Access Compliance Report

Public Rights-of-Way

(Curb Ramps)

Intersection ID: 8181	Main Street: FREEDOM_DR	Cross Street: TODDVILLE_RD	Location:	E
ADA ID: 3D7D571C8251	Ramp Type: PerpDiag	Initial Pass/Fail: Fail	Overall Compliance: No	Severity Score: 10

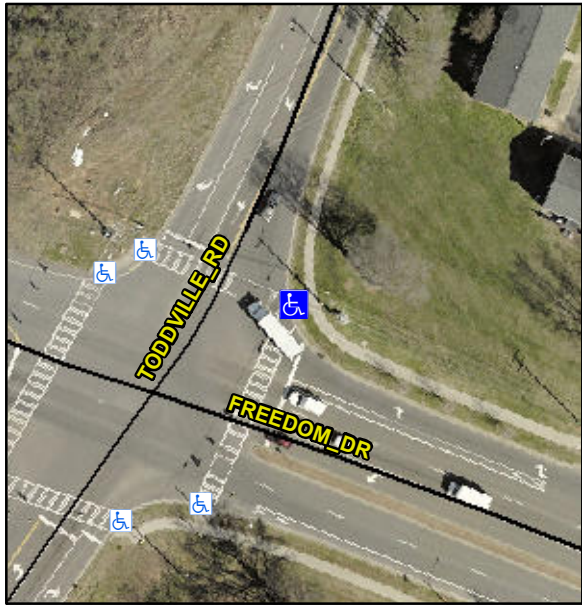
Codes/Mitigation Info/Possible Solution			Field Measurements/Component Compliance					
	Possible Solutions:		Compliance	Description	Data	Compliance	Description	Data
	Remove & Replace Curb Ramp With Two New Directional Ramps or Equivalent.		N/A	Ramp Length (in)	97.0	Yes	Ramp Slope (%)	5.9
			No	Ramp Width (in)	47.5	No	Ramp XSlope (%)	3.9
			N/A	Flare Type LT	N/A	N/A	Flare Type RT	N/A
			N/A	Flare Slope LT (%)	N/A	N/A	Flare Slope RT (%)	N/A
			N/A	Flare Traversable LT?	N/A	N/A	Flare Traversable RT?	N/A
			N/A	Landing Length (in)	N/A	N/A	DWS Provided?	N/A
			N/A	Landing Width (in)	N/A	N/A	DWS Contrast?	N/A
			N/A	Landing Slope (%)	N/A	N/A	DWS Length (in)	N/A
			N/A	Landing X Slope (%)	N/A	N/A	DWS Full Width?	N/A
Surveyor Notes:	N/A		N/A	Landing Curb? (Y/N)	N/A	N/A	DWS Offset (in)	N/A
			N/A	Shared Landing?	N/A			
	PROW/ADA:		N/A	Gutter Ponding?	N/A	N/A	Gutter Slope (%)	N/A
	Not Found, R304.5.1, R304.5.3		N/A	Gutter Lip Ht (in)	N/A	N/A	Gutter X Slope (%)	N/A

N/A	Painted X Walk1?	Yes	N/A	Painted X Walk2?	Yes
				X Walk 1 Direction	To NW		X Walk 2 Direction	To SW
			N/A	X Walk 1 Width (in)	112.0	N/A	X Walk 2 Width (in)	112.0
				X Walk 1 Slope (%)	4.7		X Walk 2 Slope (%)	0.3
				X Walk 1 X Slope (%)	1.1		X Walk 2 X Slope (%)	2.0
			N/A	Ramp inside XWalk1?	Yes	N/A	Ramp inside XWalk2?	Yes
Total Cost:				Road Slope (%)	1.4	N/A	Clear Space?	N/A
				Road X Slope (%)	2.6	N/A	Clear Space to XWalk (in)	N/A
			N/A	Any Obstructions?	N/A	N/A	Storm Grate/Utility Hazard?	N/A
				Obstruction Type			Storm Grate/Utility Type	
						N/A		N/A
						Yes	Surface Condition? (G/P)	Good
